CDM Validation Report

CDM Validation

Daegu Metro 3th Urban Railroad

324172 / P32042.33

Figure 6: Baseline and Project Emissions

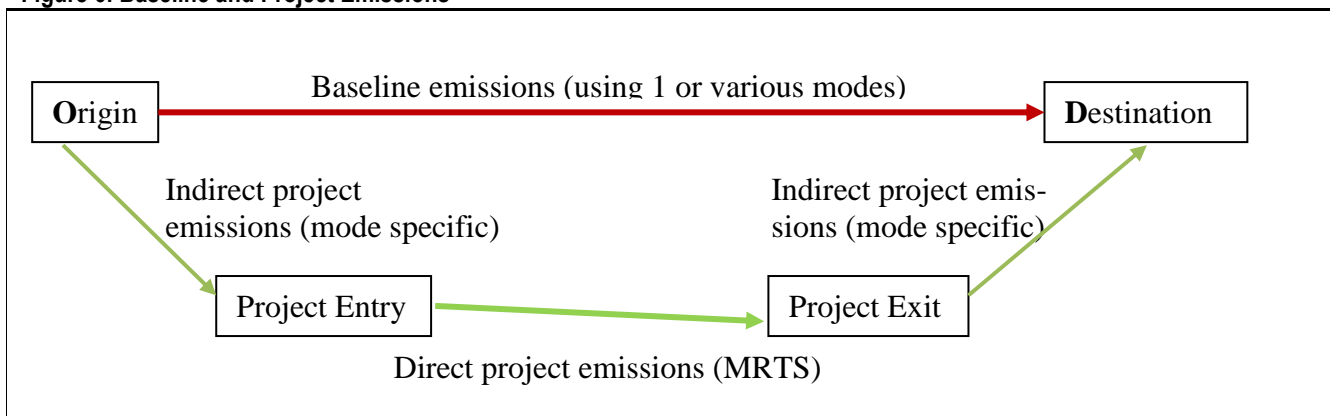
Figure 6 gives an overview of baseline and project emissions, the latter being differentiated in indirect and direct project emissions.
